24 March 2021

Selwyn District Council CHRISTCHURCH

Re: Request for Further Information – Plan Change 76

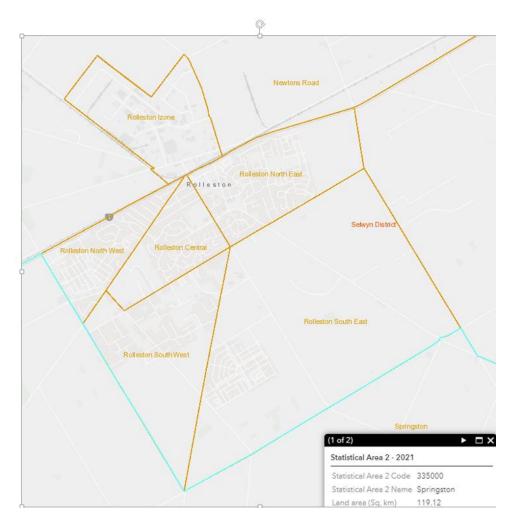
4. The request relies on Policy 8 of the NPS-UD, in that it would add significantly to development capacity. In Appendix 10, when responding to this policy, as well as to Policy 6, it is stated that the request will add "an additional 3% over and above existing zoned supply". Please set out how this percentage figure has been derived.

The statement 'an additional 3%' is imprecise to the extent that the calculation is rounded up and was derived by taking the 2018 census record of all dwellings (occupied, vacant, under construction) in the five statistical areas making up Rolleston and deriving the percentage that 155 lots adds to that 2018 figure (155/6164 = 2.52%). It was intended to give a sense of scale.

It was not a figure that was derived by assessing the Site's contribution to available development capacity as reported to the 9 December 2020, Council meeting in the Housing and Business Development Capacity Assessment for the short, medium and long term as that was not available at the time of the plan change application.

The Update data that shows that there is a short term available capacity of +2543 developable lots in the Greater Christchurch Urban Area within the District in the short term (2020-2023). That is lots within existing development areas that are zoned and feasible for development. If this Plan Change is adopted it would have the effect of increasing this supply of lots to +2698 lots. The155 lots in this Plan Change proposal represents an additional 5.7% (155/2698) of available capacity for the Greater Christchurch Urban Area within the District in the short term. As such the additional lots will not overwhelm the existing supply, but rather provide a proportionate buffer to any unevenness in uptake of lots.

Similarly when assessed against the medium term case of the reported Update shortfall of 2737 dwellings in the medium term, the 155 lots in this proposal can provide potentially

5.6% (155/2737) towards meeting that shortfall. In that regard it provides a significant contribution to the imminent medium term under capacity and in a location that is and has undergone significant recent and on-going growth.

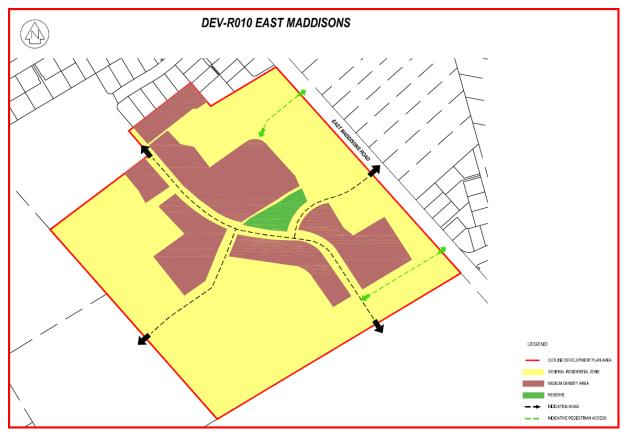
15. While the proposed ODP appears to be reasonable based on the main roading connections on their own, there are concerns in relation to how the local network and further connections to East Maddisons Road will practically work. In the proposed subdivision layout included in the request, a road/intersection (which appears to have the same status as the main ODP roads) is positioned too close to the realigned section of East Maddisons Road/Goulds Rd Intersection, as shown below. Please revise the ODP to avoid this type of outcome at any subsequent subdivision consent stage.

Attachment 1 is an amended ODP which shows the principal roads only, with a main indirect east-west road, connecting onto East Maddisions Road in a central position within the subdivision as below.
